Value Engineering Study

Final Report

VE Number: 202303

I-75 Widening, MP 20.2 to MP 28.851 Laurel & Whitley Counties

12

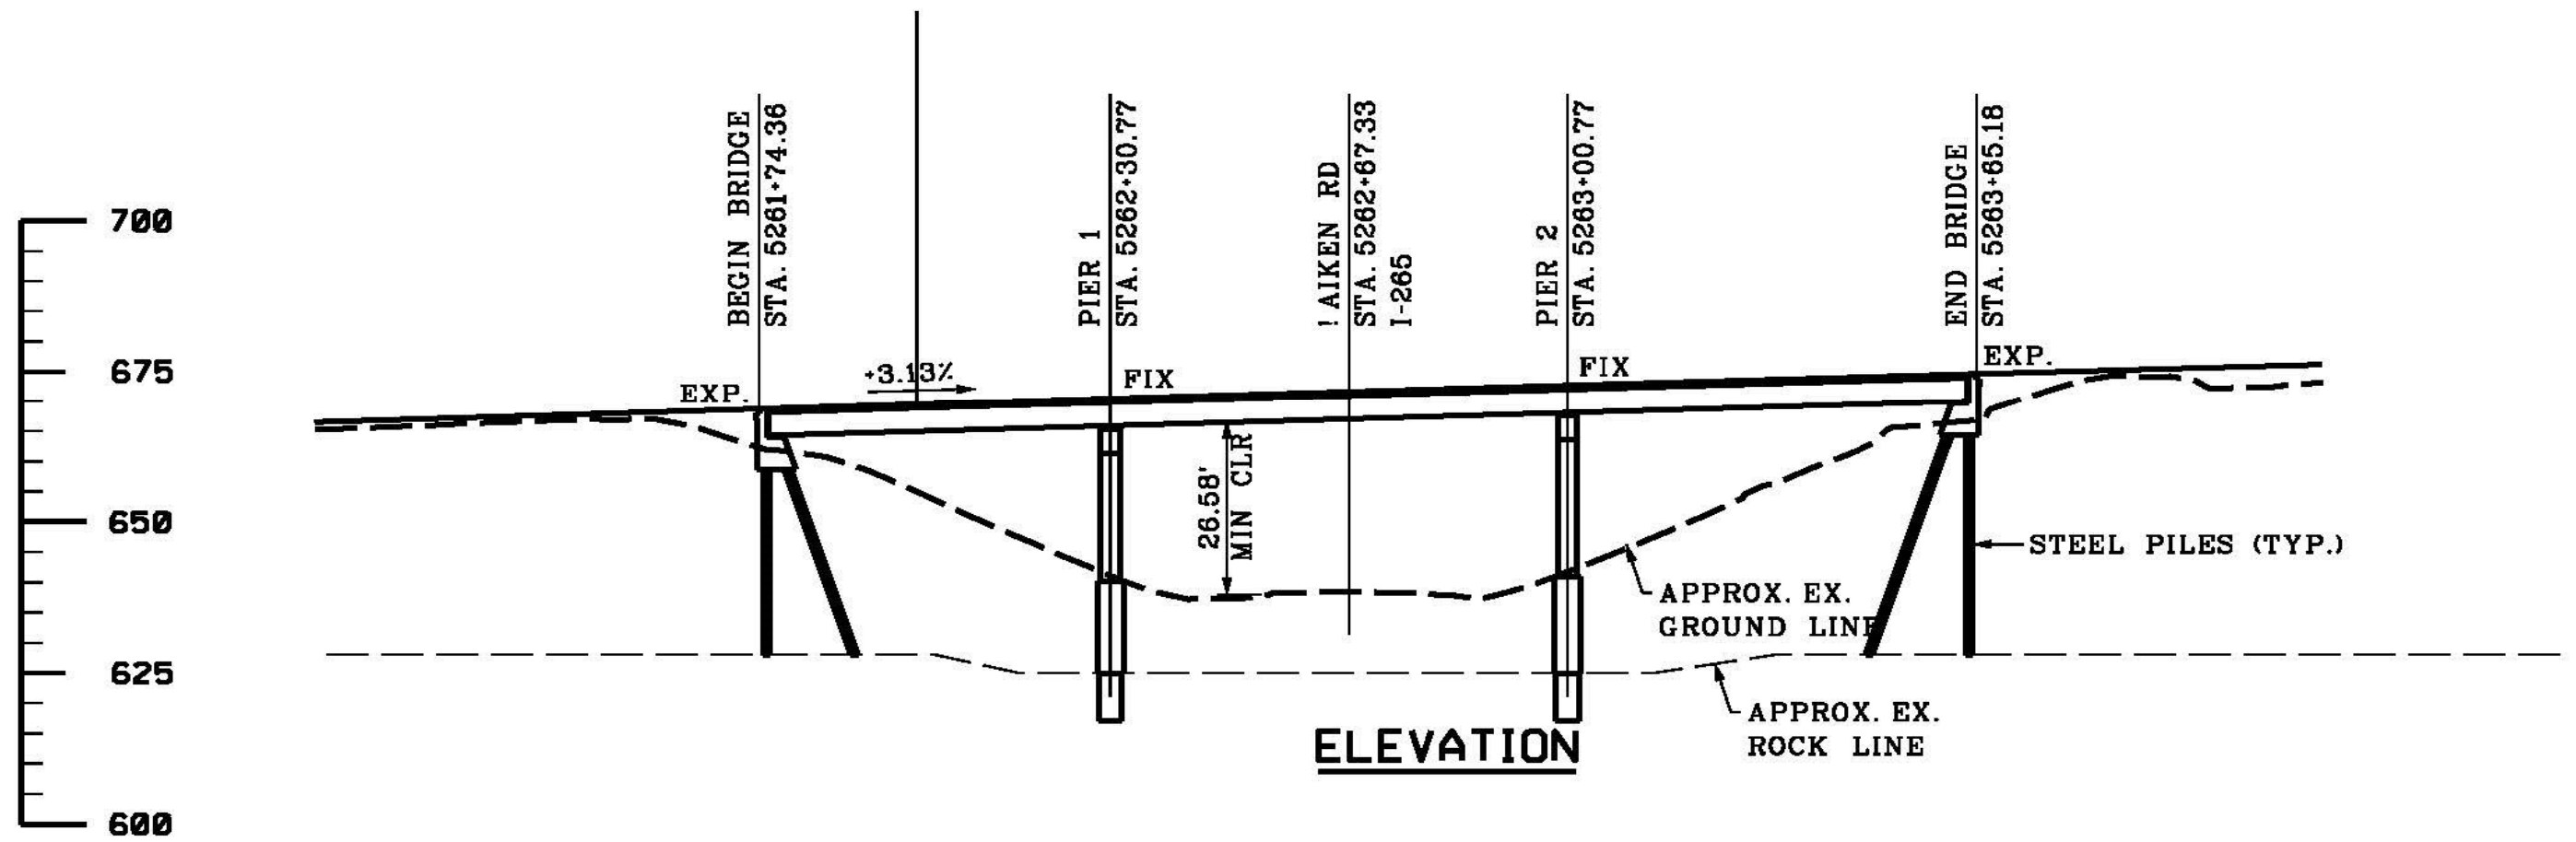
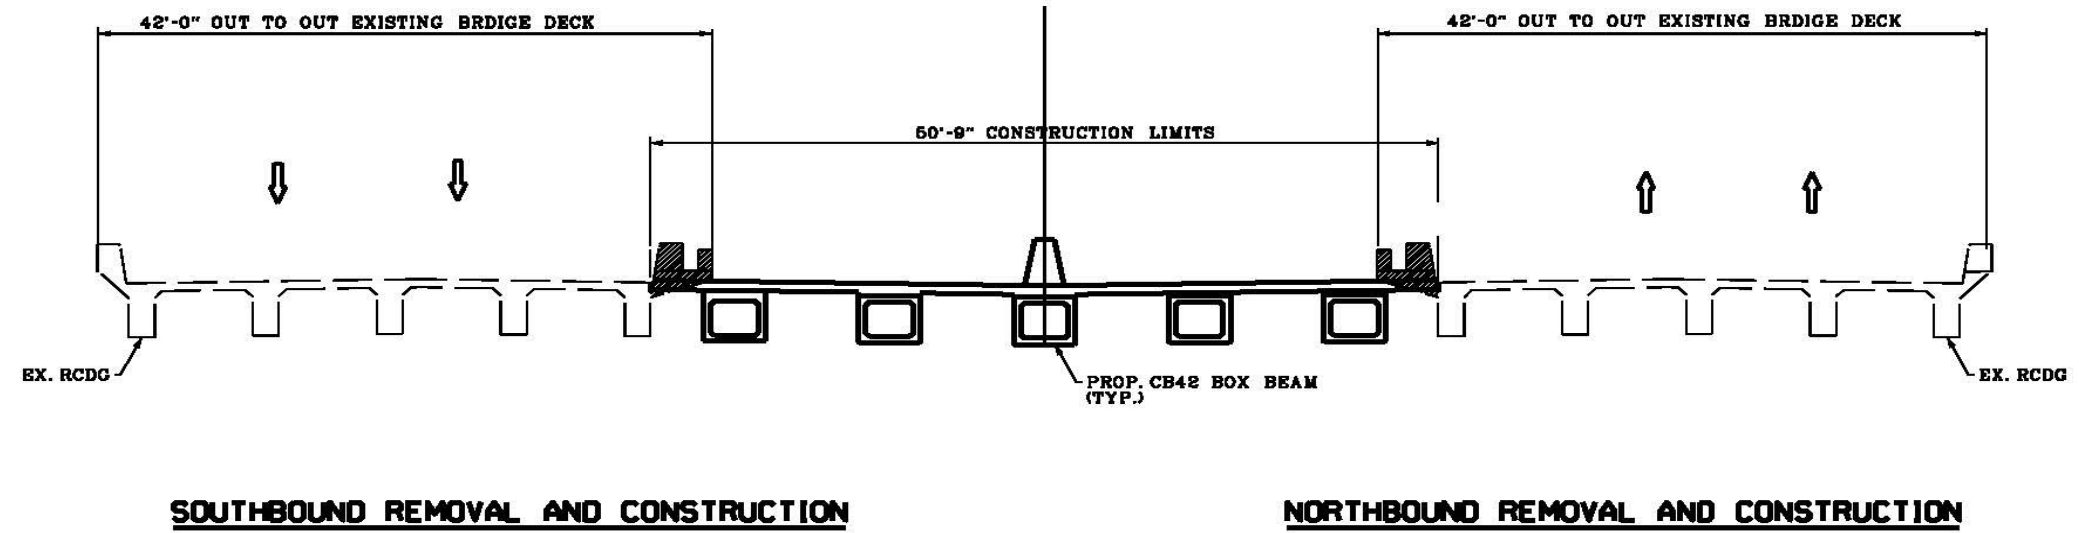
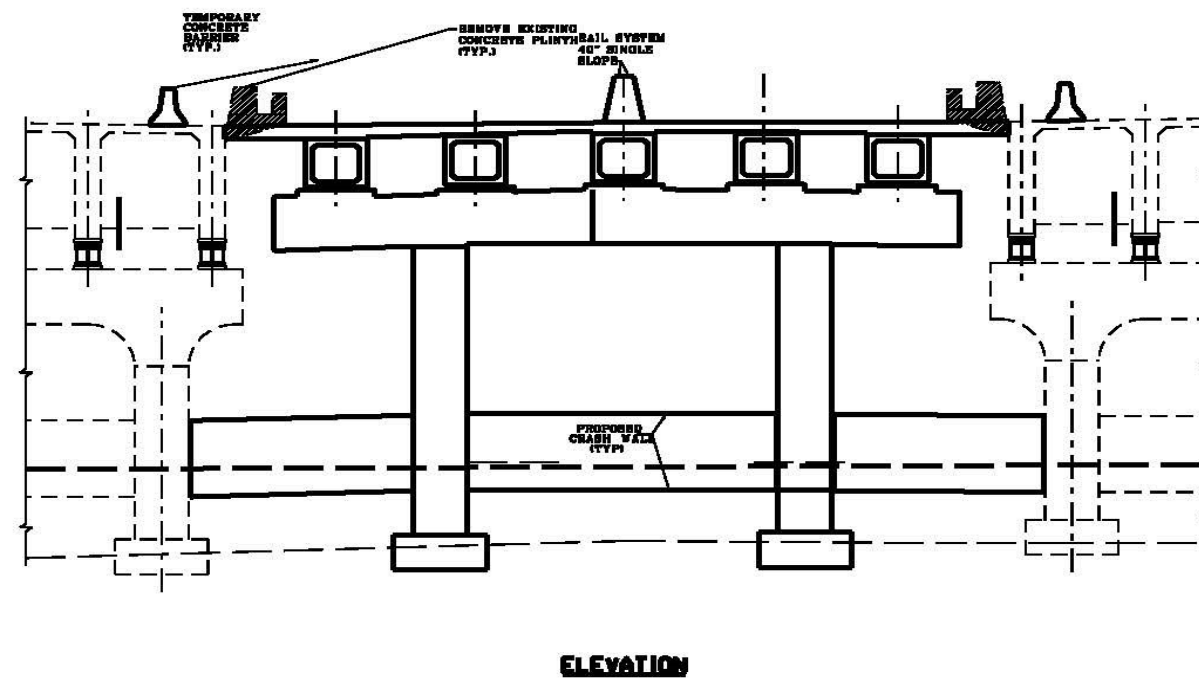
TITLE	Strengthen and refurbish the Exit 25 bridge and widen to accommodate new lanes		
VALUE PROPOSAL SYNOPSIS:			
The existing bridge can be utilized in the widening and reduce the cost of removing the existing bridge and building a wider new bridge.			
 Reliability	Maintained	 Functionality	Maintained
 O&M	Maintained	 Schedule Impact	Improved
			\$ Initial Cost Avoidance (Add)
			\$2,070,000
BASELINE CONCEPT:			
A new bridge (3 span PCI beam) designed to the current specifications would be the constructed at this site. The original bridge will need to be removed.			
VALUE PROPOSAL DESCRIPTION:			
The existing bridge is a twin continuous RCDG bridge. This bridge style has a history of low on going maintenance cost and has robust load carrying traits (even though designed to HS20). Integrating the existing bridges in the final structure saves considerable construction cost by only constructing a portion in the middle.

TITLE	Strengthen and refurbish the Exit 25 bridge and widen to accommodate new lanes
DISCUSSION & JUSTIFICATION:	
<p>The information provided by the project team led the value team to conclude the baseline design for the exit 25 structure would be to remove and replace with a new structure meeting current design criteria. Based on the information the value team has, we believe current vertical clearances exist for the structure. The existing structure is a twin continuous RCDG bridge which, depending on analysis, appears to be in good condition.</p> <p>The value team proposes constructing and integrating a new structure between the two existing structures and strengthening the existing structures to obtain the desired load rating. The history of the RCDG bridges have proven them to be low maintenance structures that have weathered the course of time to still thrive as reliable dependable bridges today. With some strengthening of the structure the HS20 design can be brought up to current standards.</p> <p>By not having to replace these two structures, the bridge at exit 25 can be constructed much more quickly with less traffic shifts, less materials, shorter construction time, less cost, and much less impacts to the traveling public.</p>
